Submissions Report

South Coree Battery Energy Storage System

Berrigan Shire, Finley, NSW

Project Number: 251103

Appendix C Updated layout plans

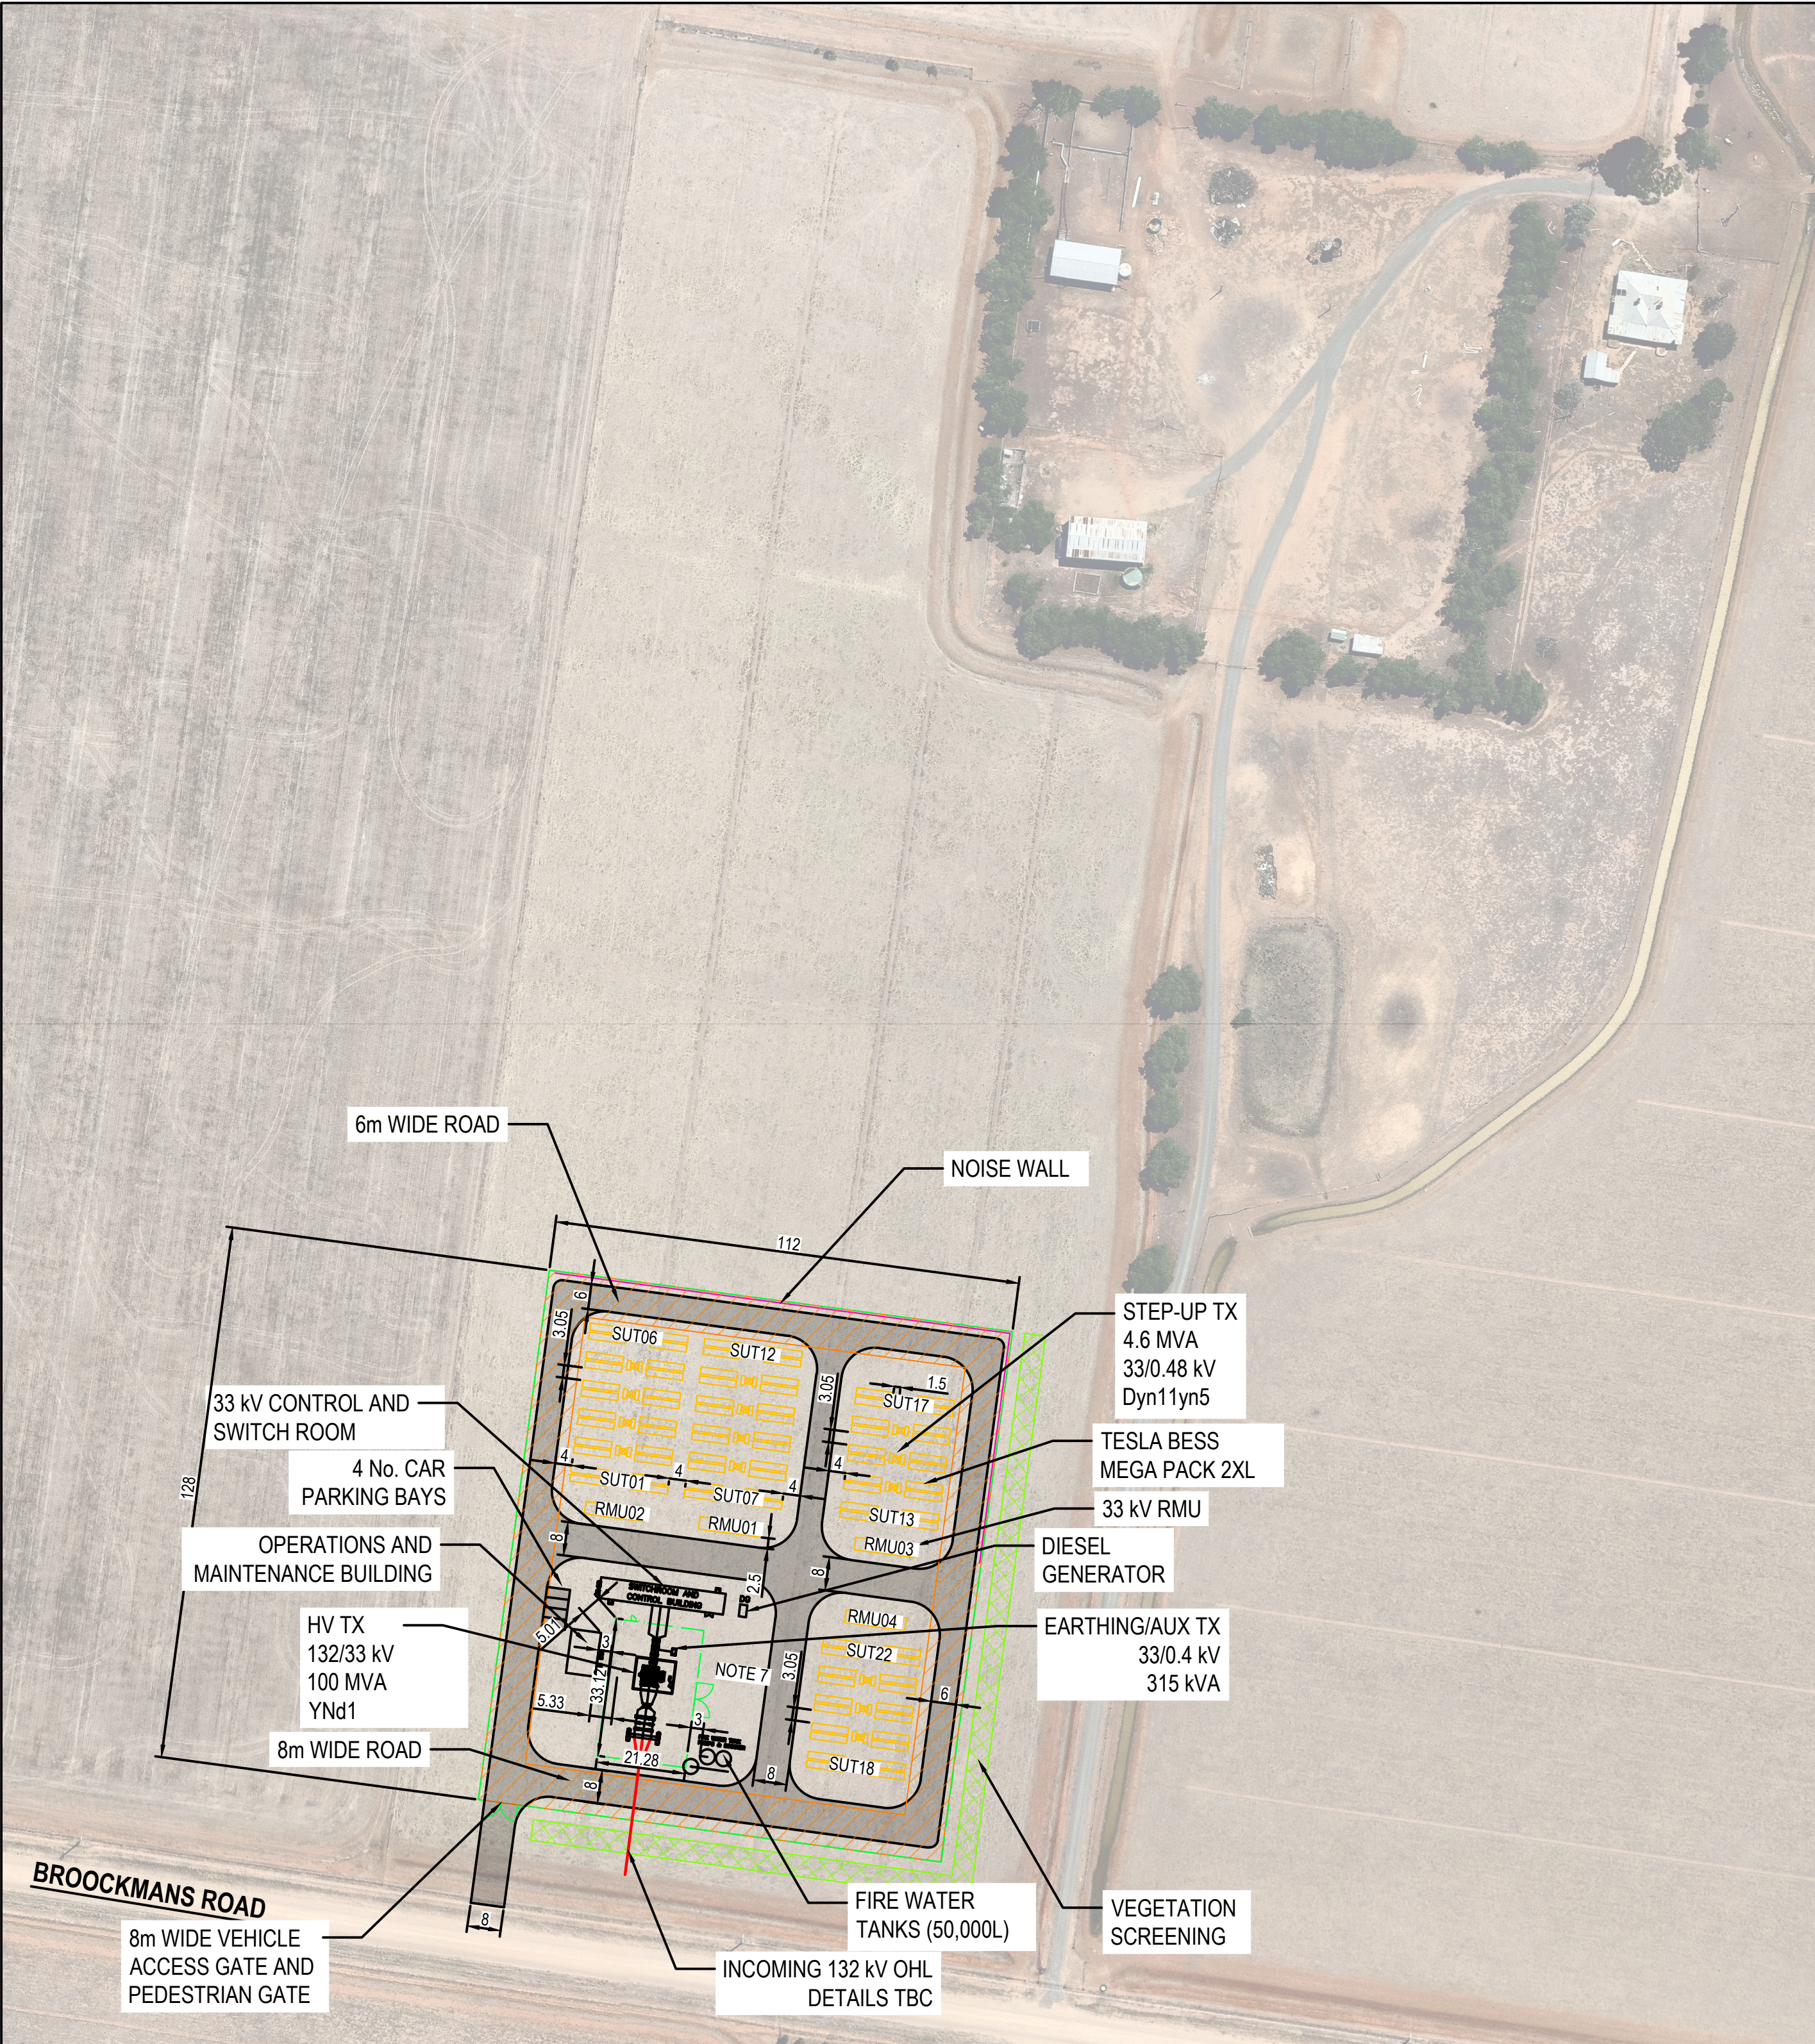
Submission	Response	Reference location
Re-examine the area allocated for the batteries and demonstrate that the layout allows for adequate spacing to minimise the risk of fire propagation, incorporating the findings of RFI 2 (if necessary).	The updated layout and Development Footprint assessed as part of the EIS allows for adequate spacing to minimise the risk of fire propagation.	Appendix C Appendix D.2
